LEGACY CHURCH - GREEN MOUNTAIN FALLS, CO DEVELOPMENT PLAN

COVER SHEET
SHEET 1 OF 13

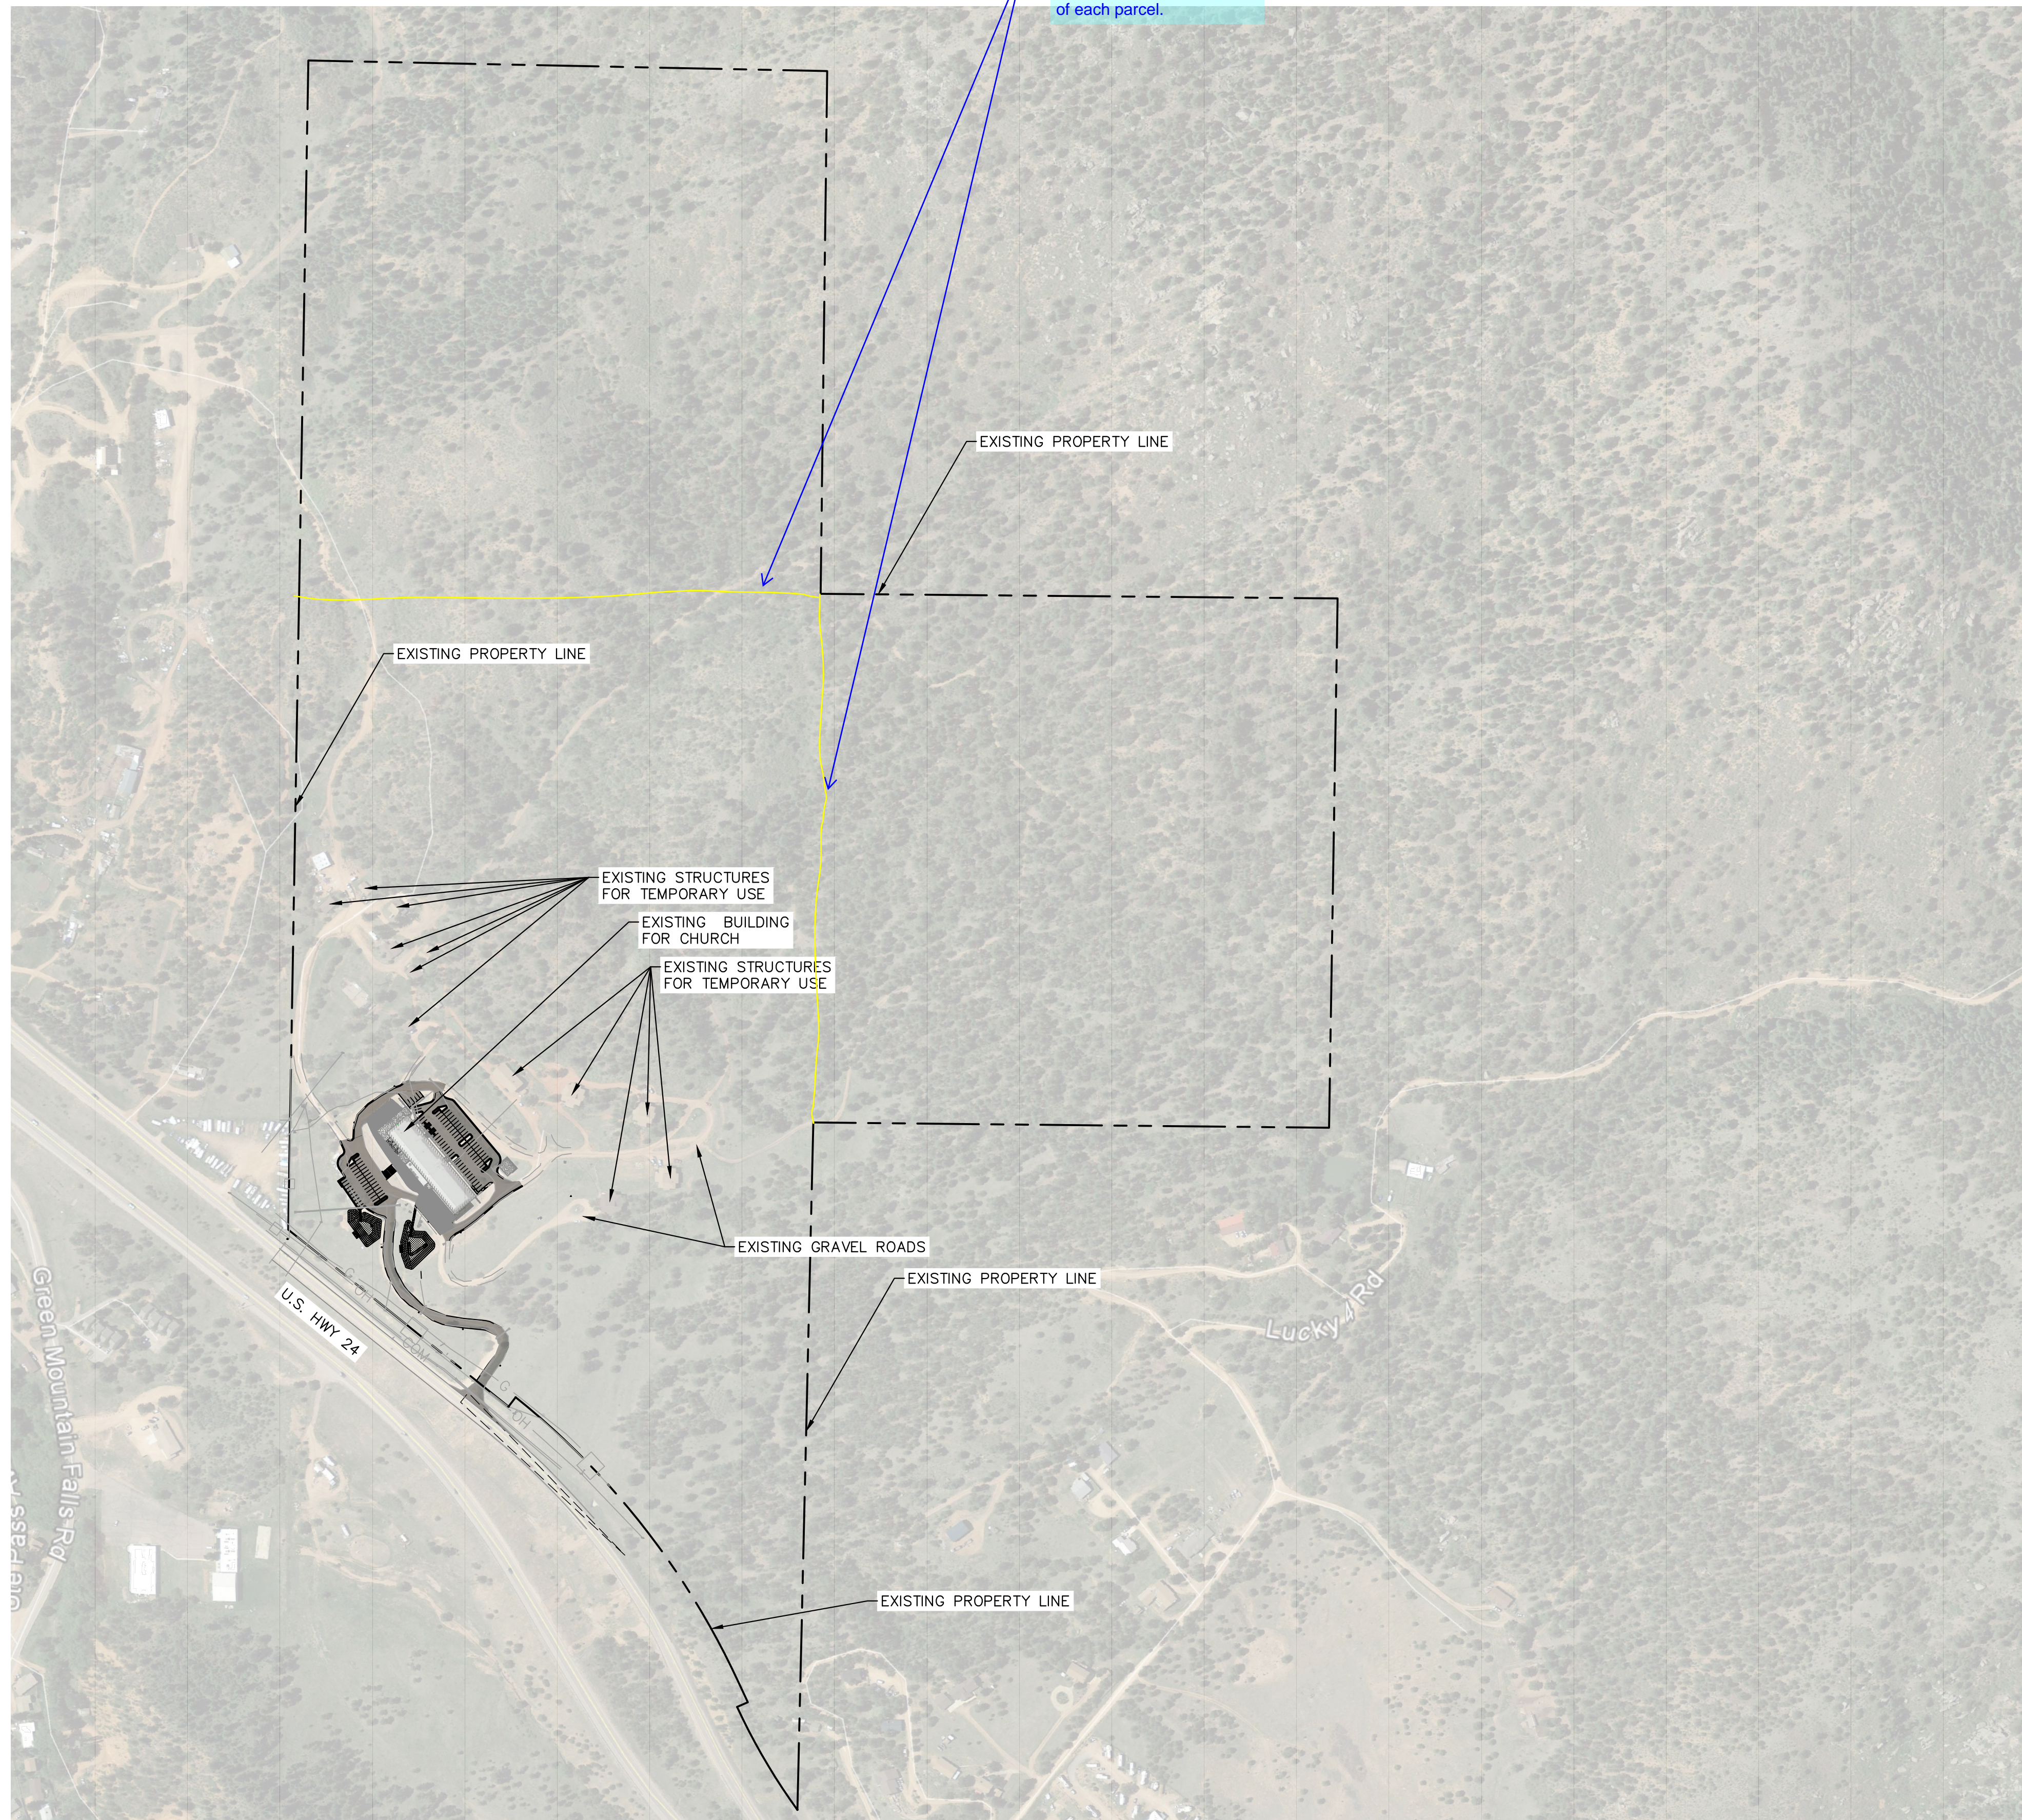
Please revise DSD to PCD

Please remove county signature block. This is not required on a site development plan.

ISSUED: 7/19/19
OVERALL SITE PLAN
SHEET 2 OF 13

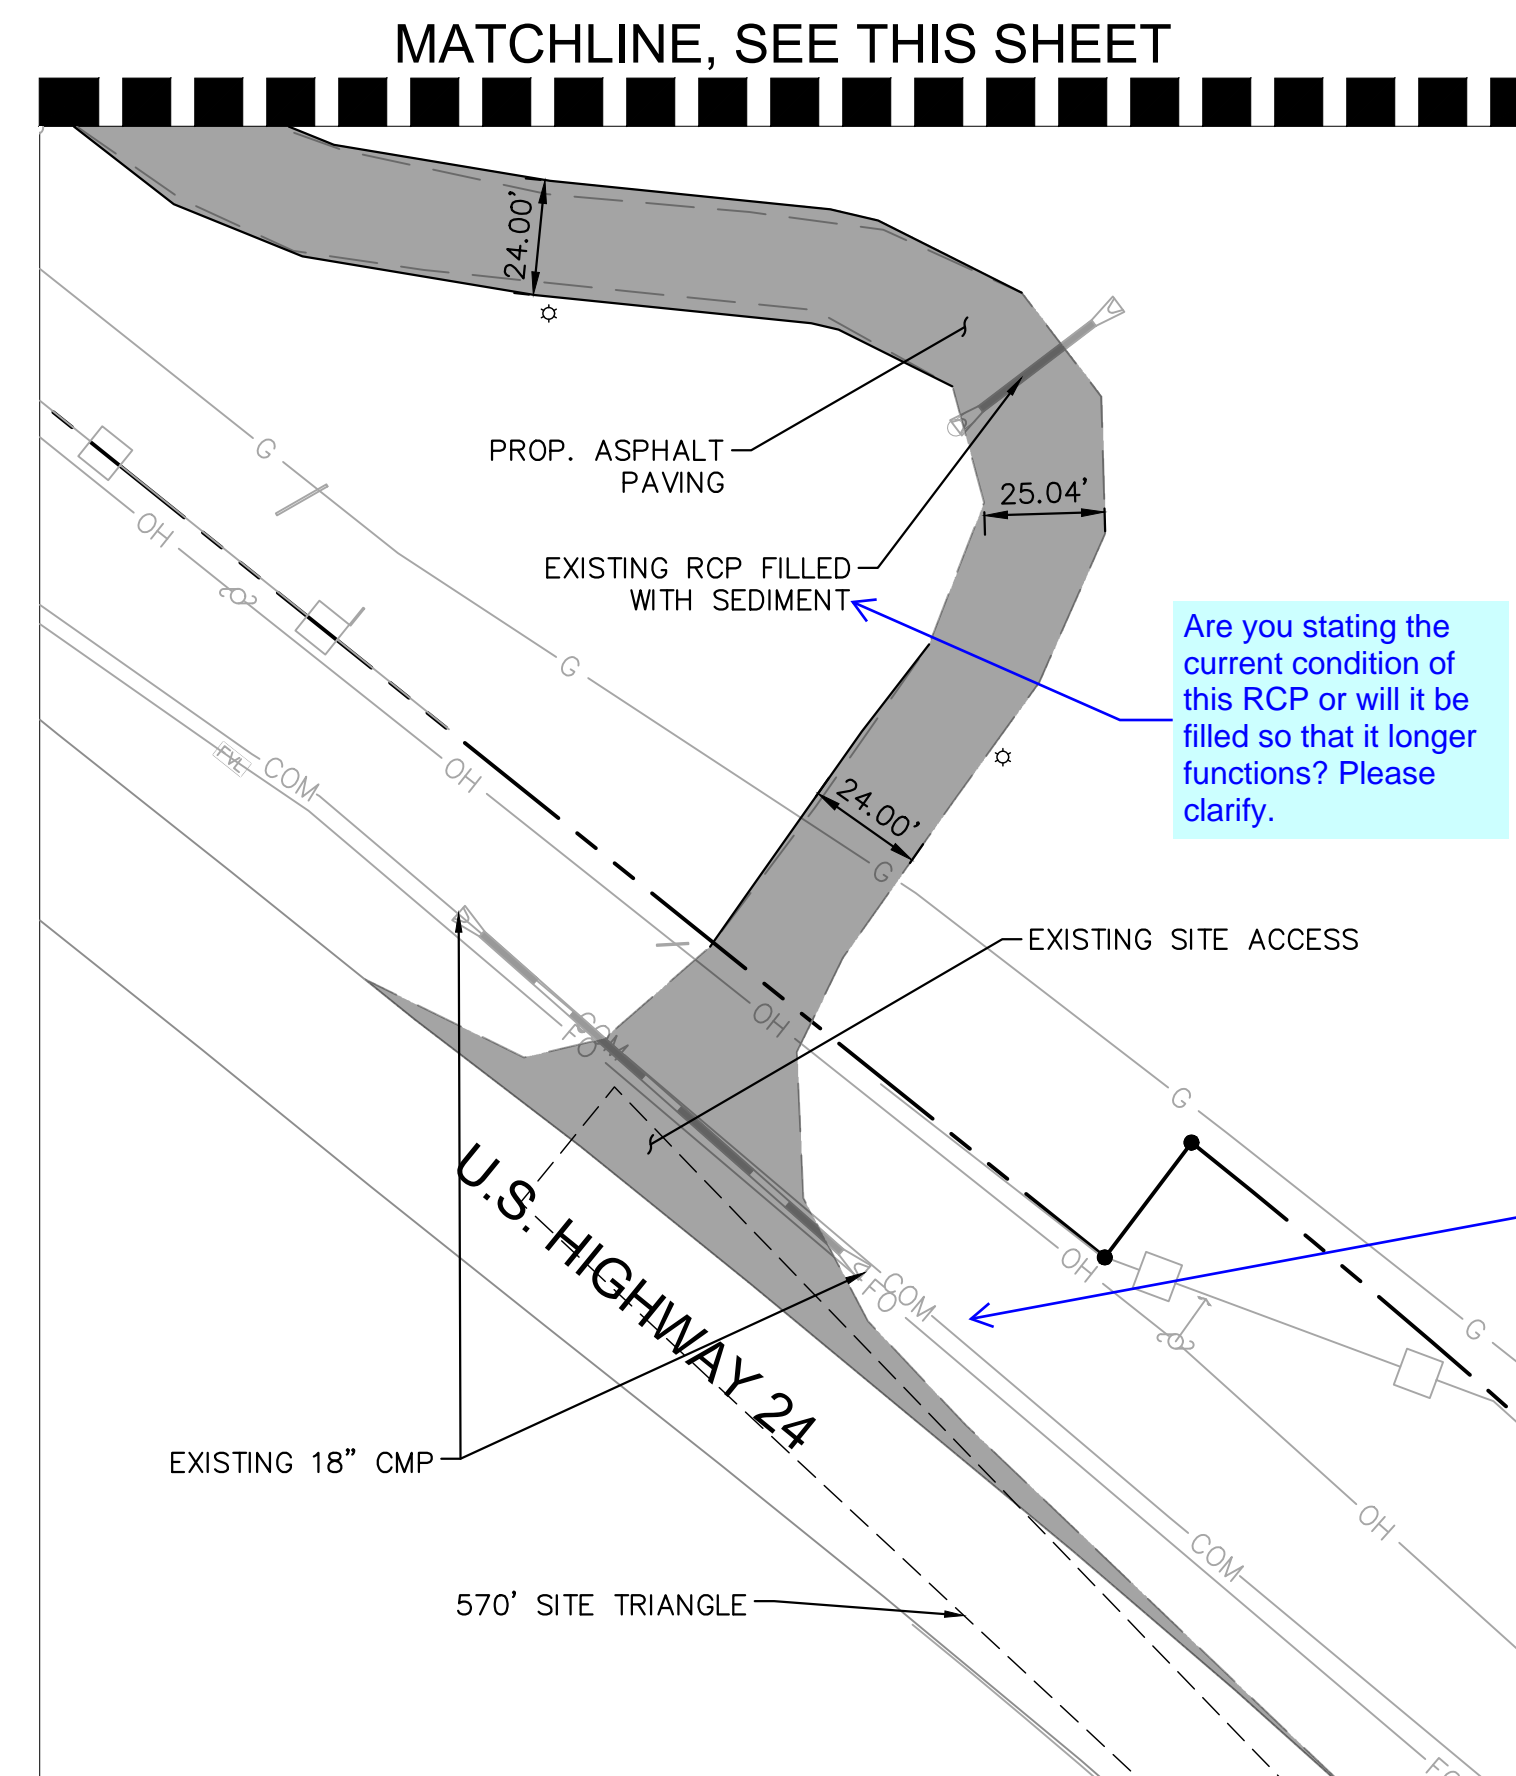
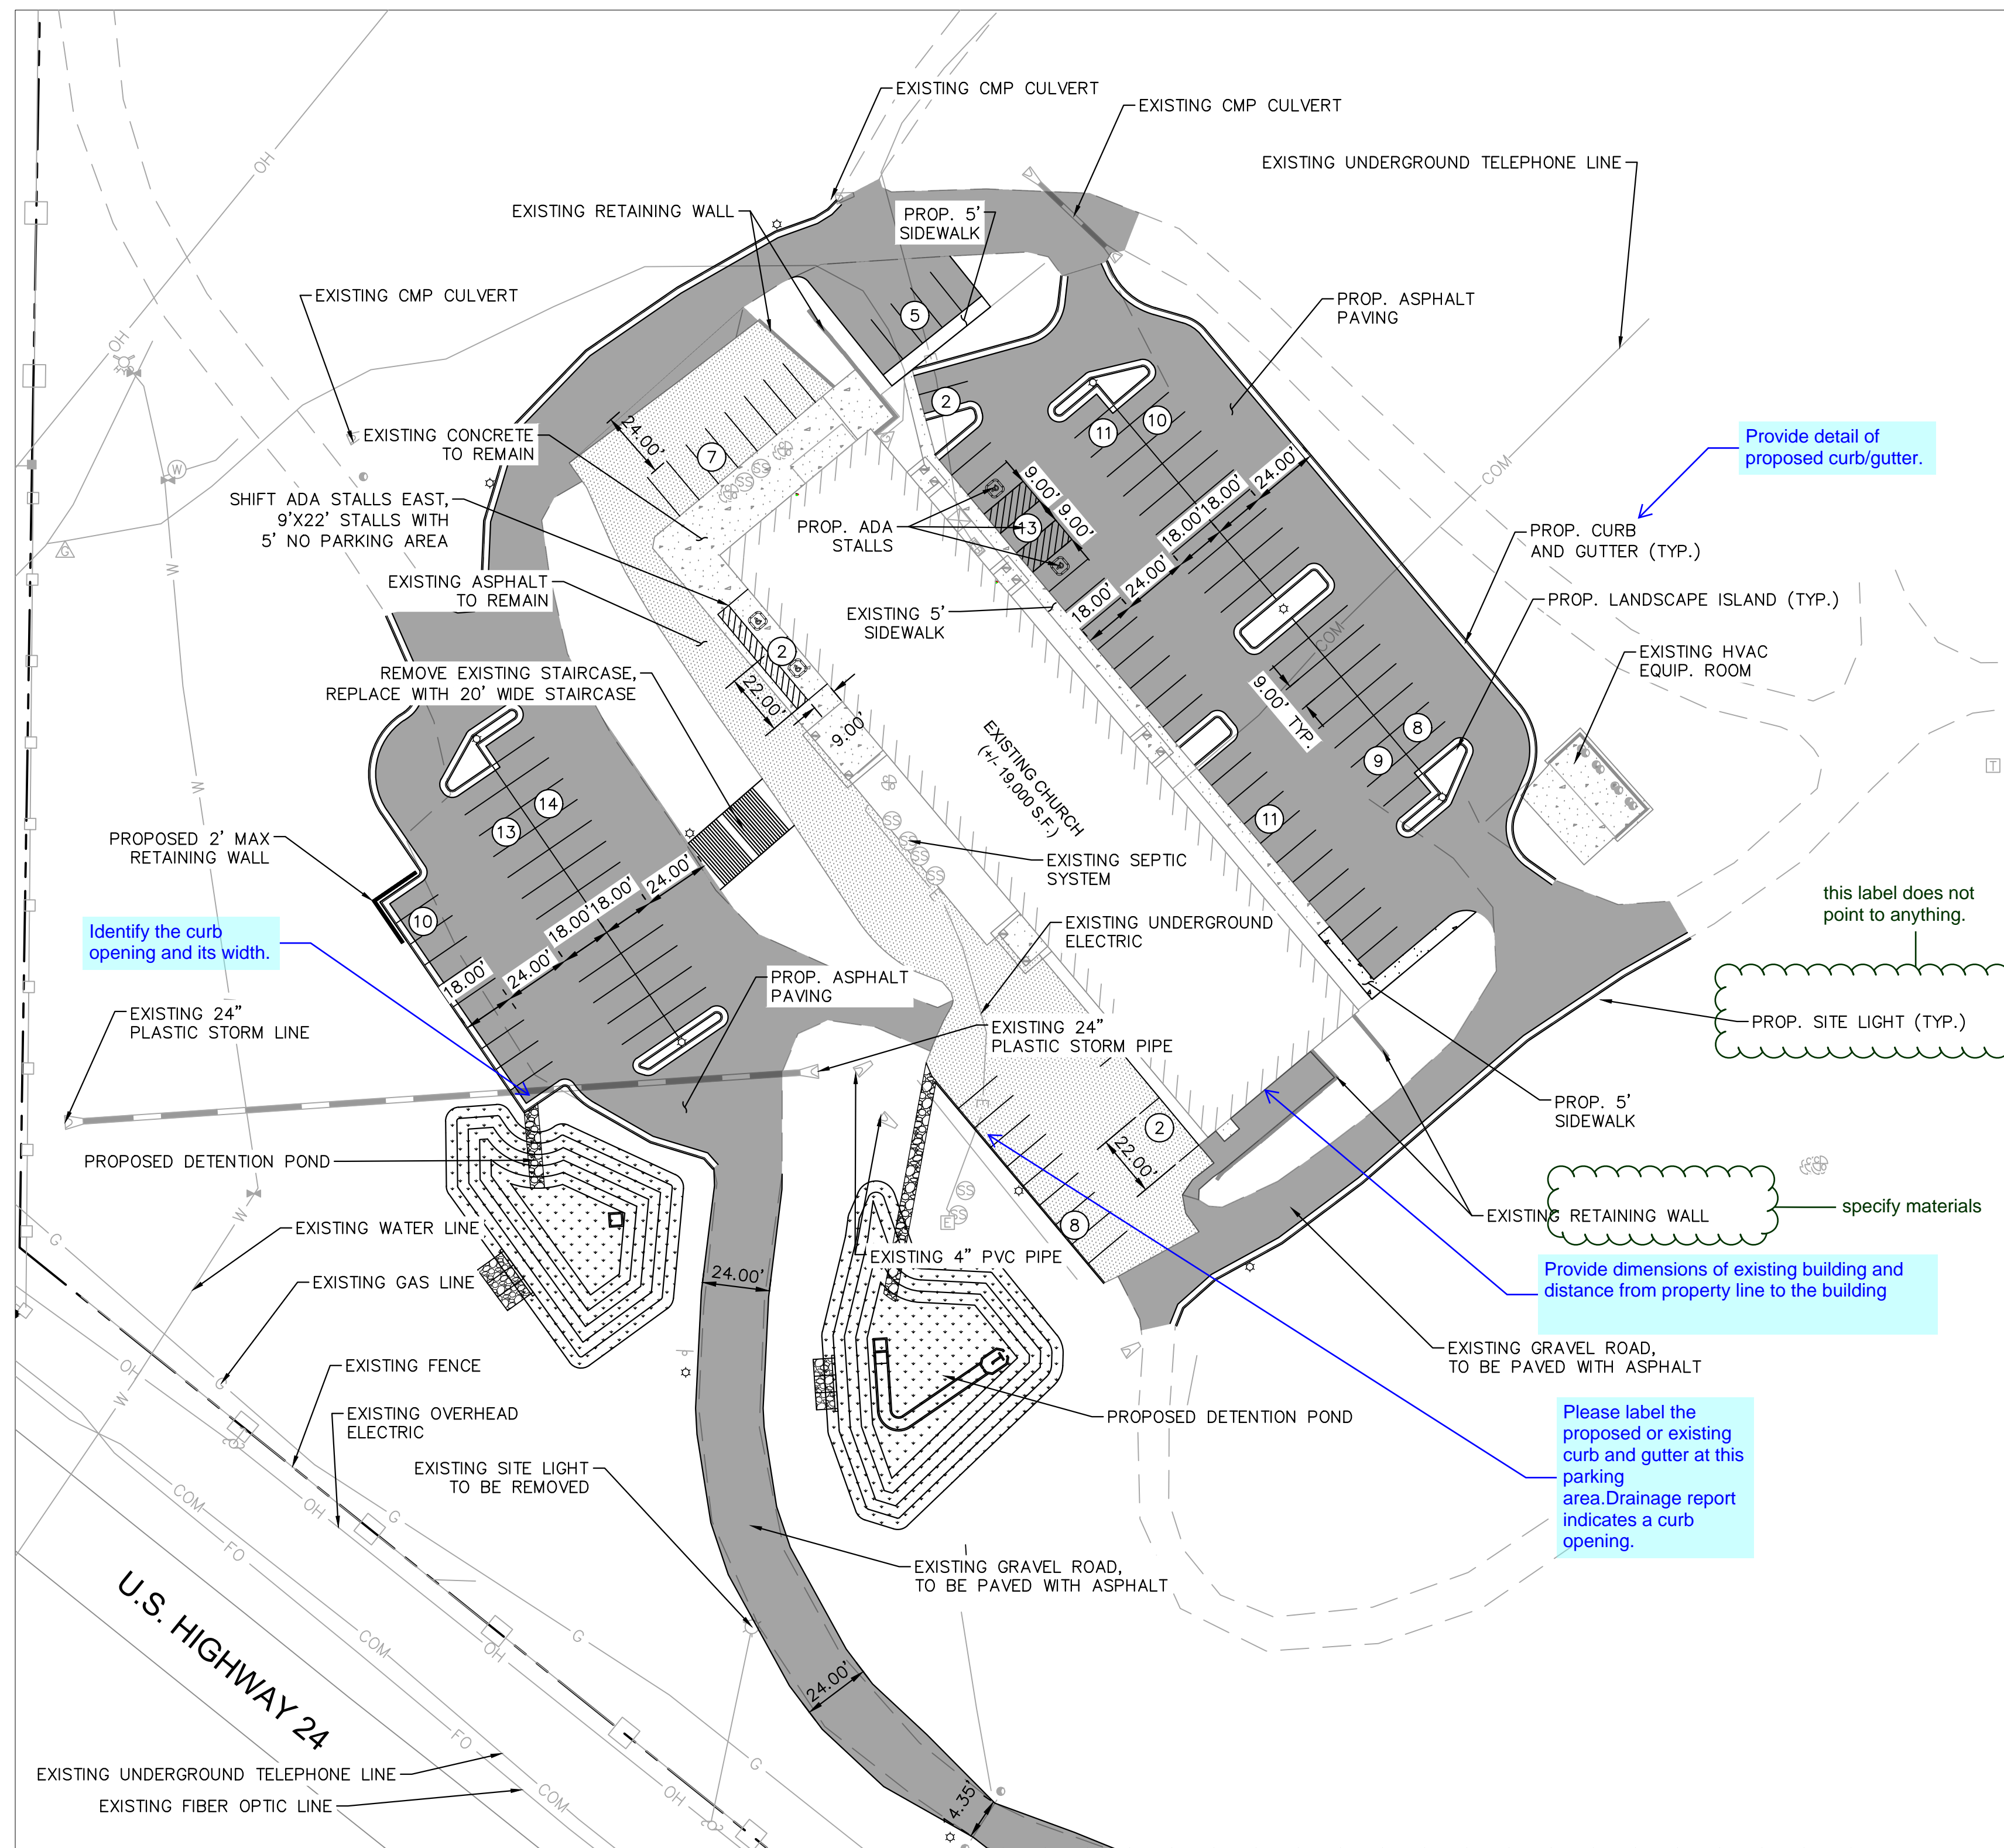
Please provide a project summary with information such as: property parcel number(s), address, zoning, lot size, sq.ft of church building, capacity/seats of church/sanctuary etc.

Provide the parcel number or name and address of adjacent property owners.
